Mark Hutchinson  
Environmental Programs Manager  
San Luis Obispo County Dept of Public Works  
County Government Center Room 207  
San Luis Obispo, CA 93408 Telephone 805.781.5252

State Clearinghouse Number: **2007121034**  
Comments Must Be Received By: January 30, 2009

Enclosed please find my comments for the LOWWP DEIR, including a few attachments for clarity.

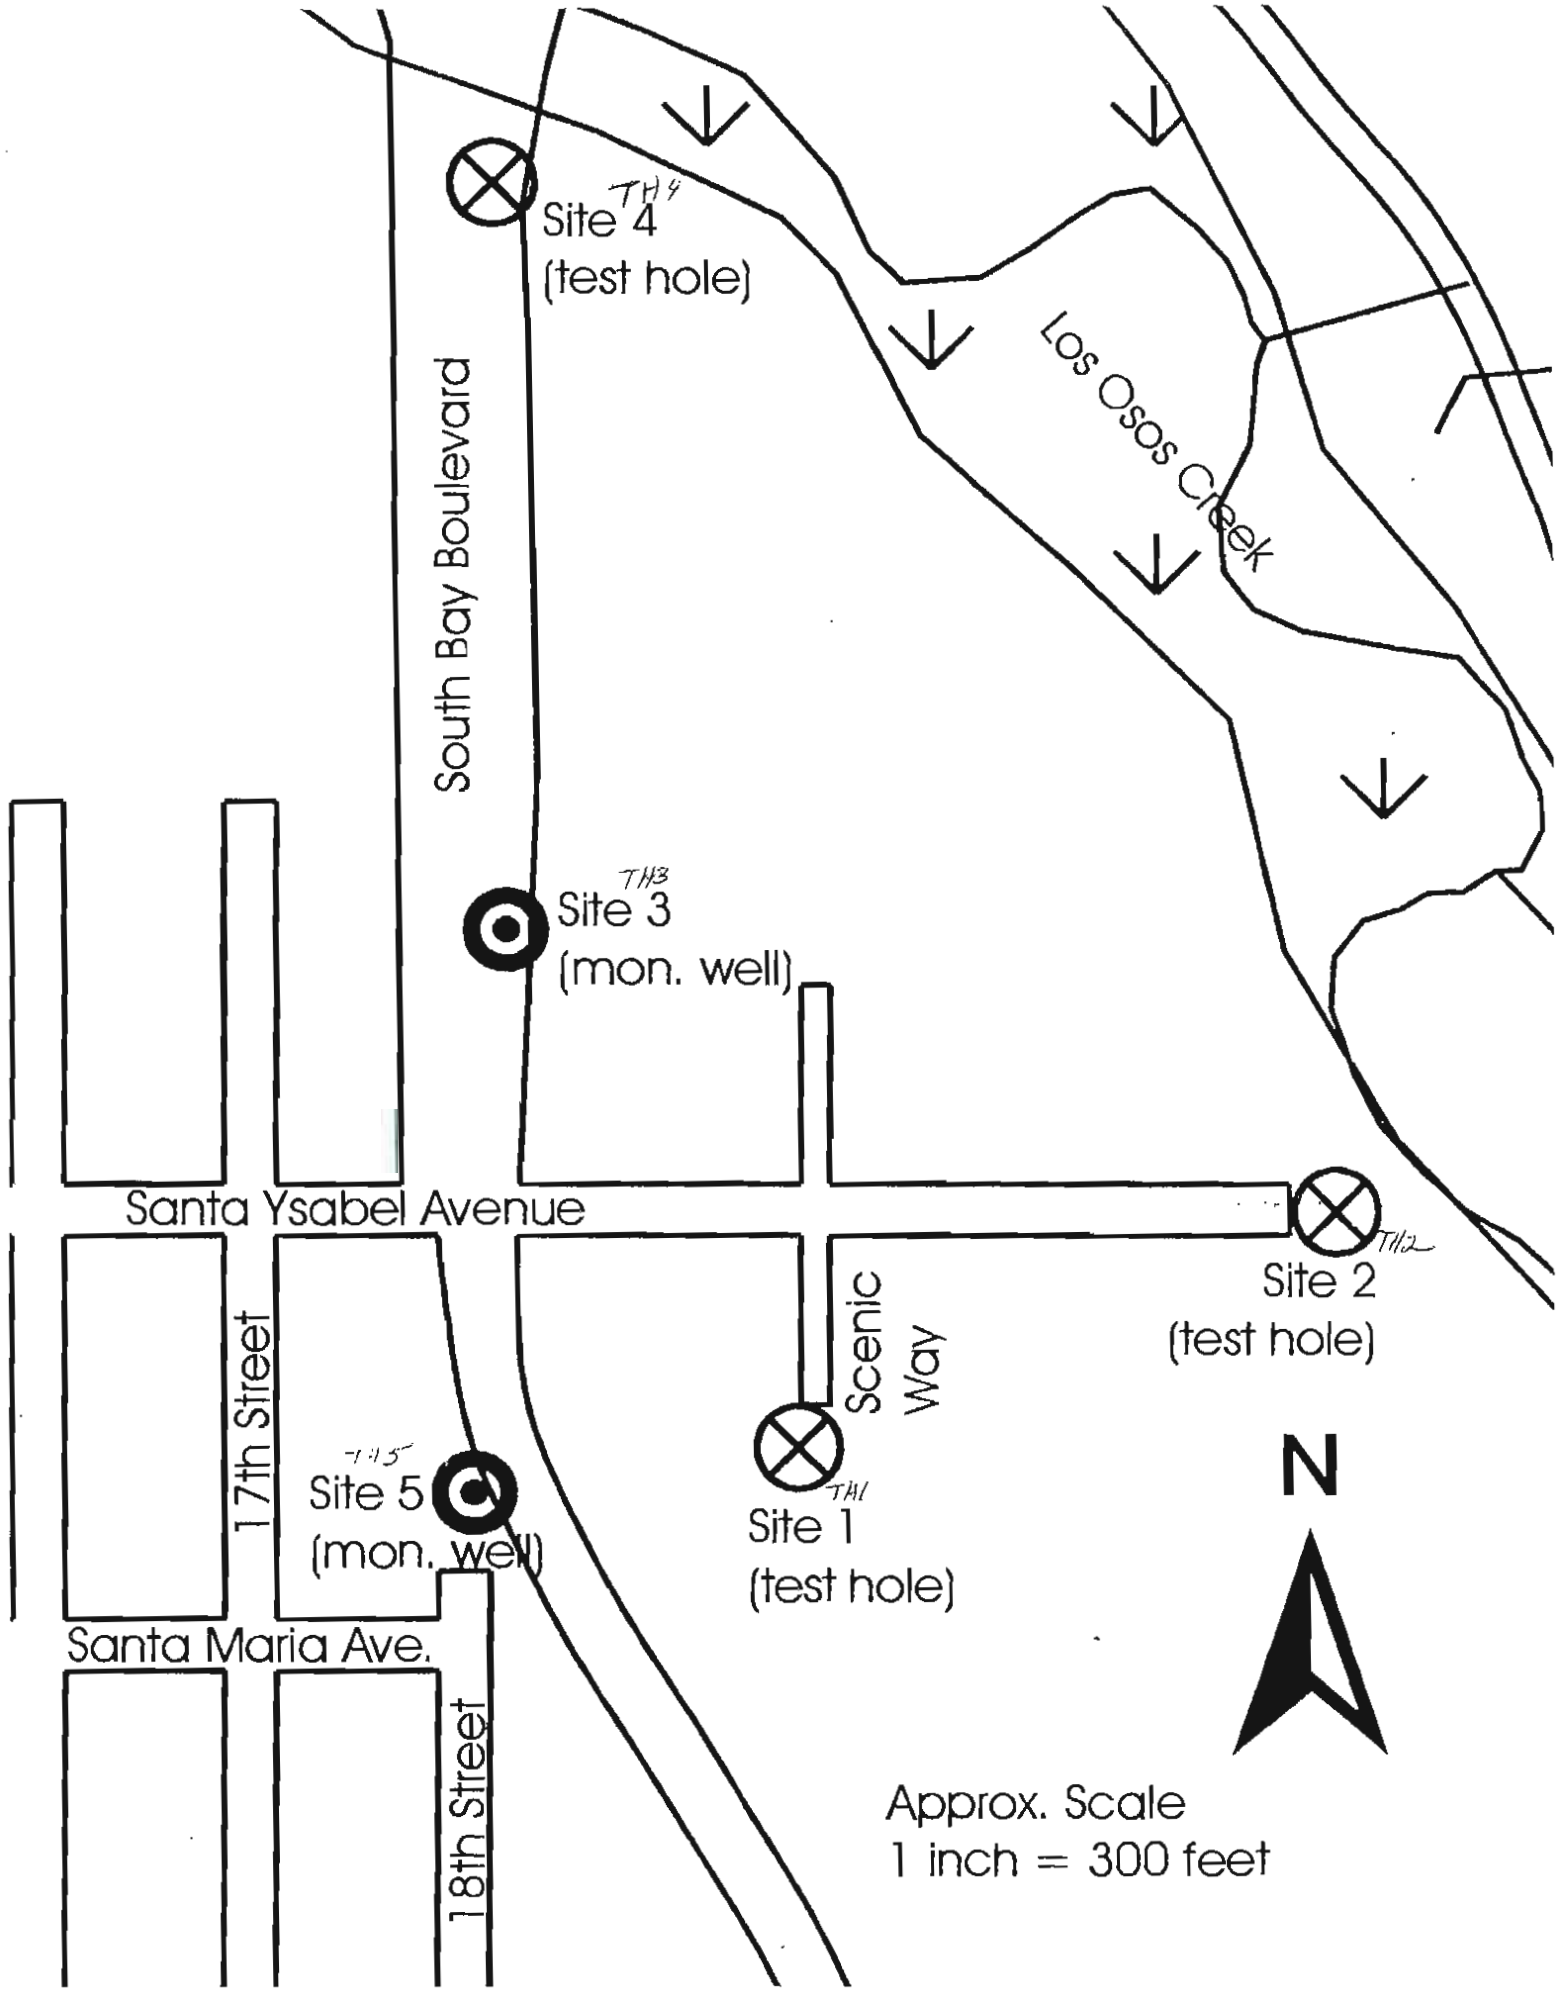
ie: The DEIR's Appendix P (on Page A-4, under Appendix A: Past Project Documents) lists a Cleath & Assoc. report titled "Scenic Way Investigation with East Side WW Disposal (Draft) July 2003 (map & info: see attachment 1)

- two test holes in this report, "TH2 & TH4, were drilled at the perimeter of the ground water basin" and "intercept Franciscan Formation metavolcanics at depth".

= Is there a possible path to the lower aquifer near here?

Figure 3-2  
Wastewater Collection Area &  
Proposed Septic System Maintenance  
and Management District

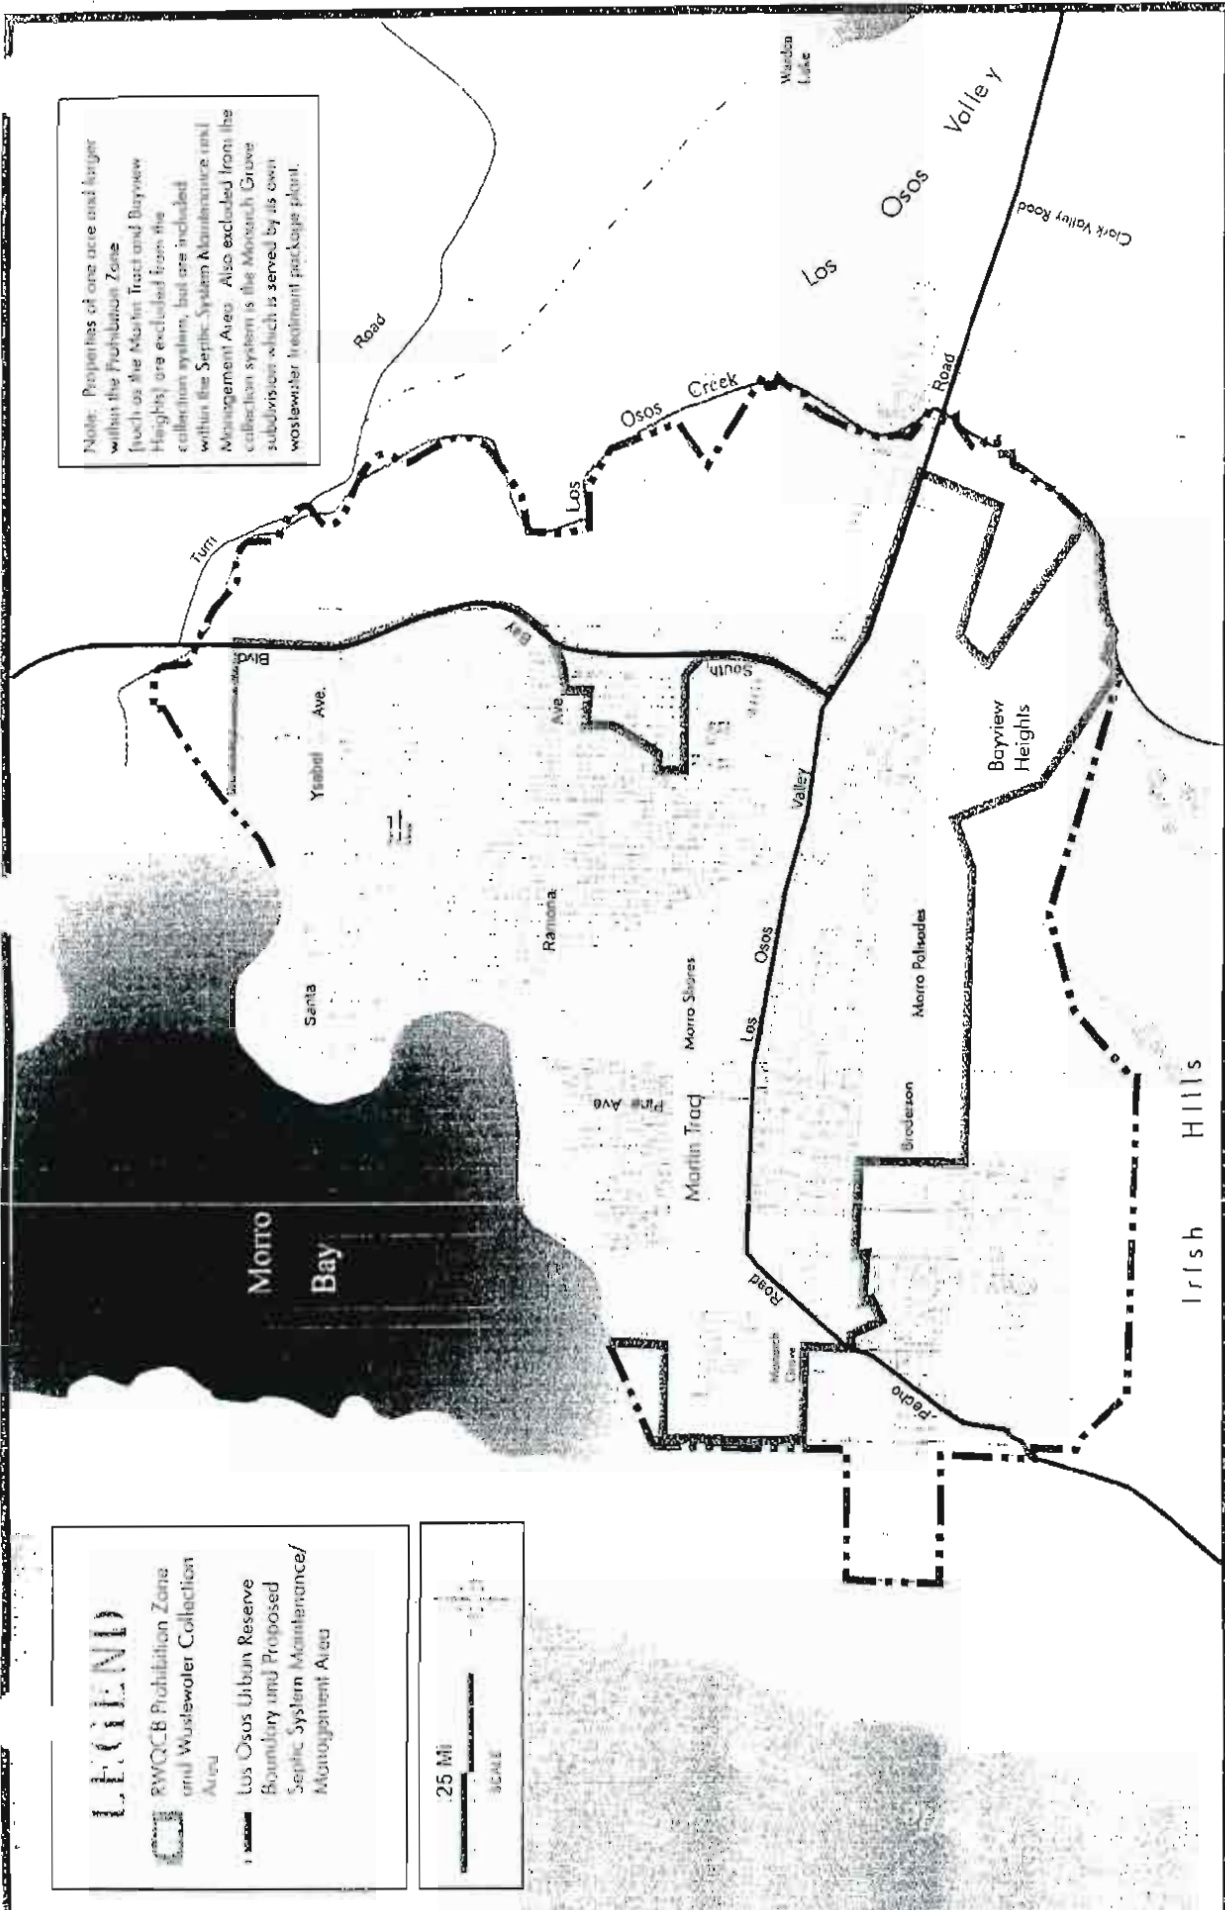
= These tables use the Urban Reserve Line as the focus boundary and the RWQCB Prohibition Zone/collection Area (87% of Urban Reserve Line) is listed as 17,963; (on following page there is more explanation "the collection area is approximately 78% of the total area within the RWQCB Prohibition Zone"... "and about 47% of the area within the Urban Reserve Line for Los Osos"..... )

LOS OSOS URBAN AREA: COMMUNITYWIDE

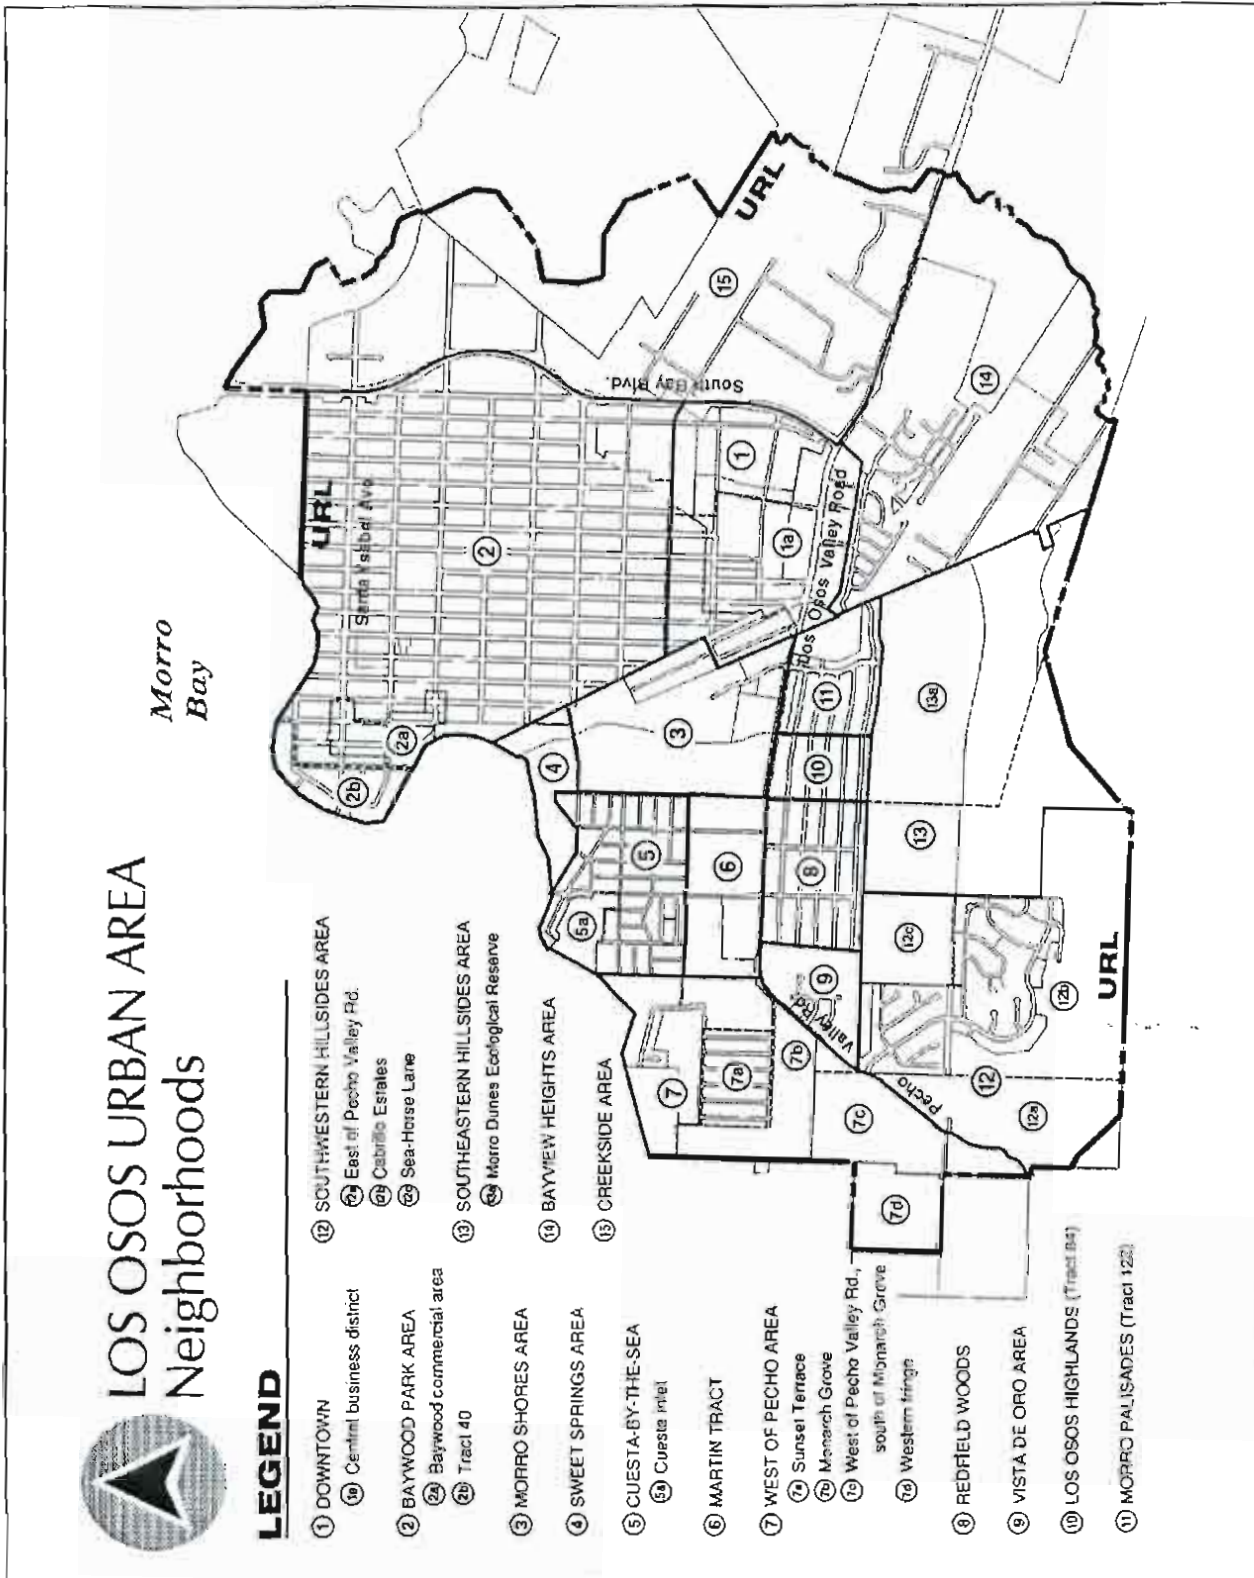
= this document says total population at buildout to Urban Reserve Line is 20,590 (check this information against your table!) (I am attaching an Estero Map to show the URL. line with the LO Urban Neighborhoods) (see attachment 3)

NOTE: the maps in the Estero area document use the Urban Reserve Line as the main boundary for LO.
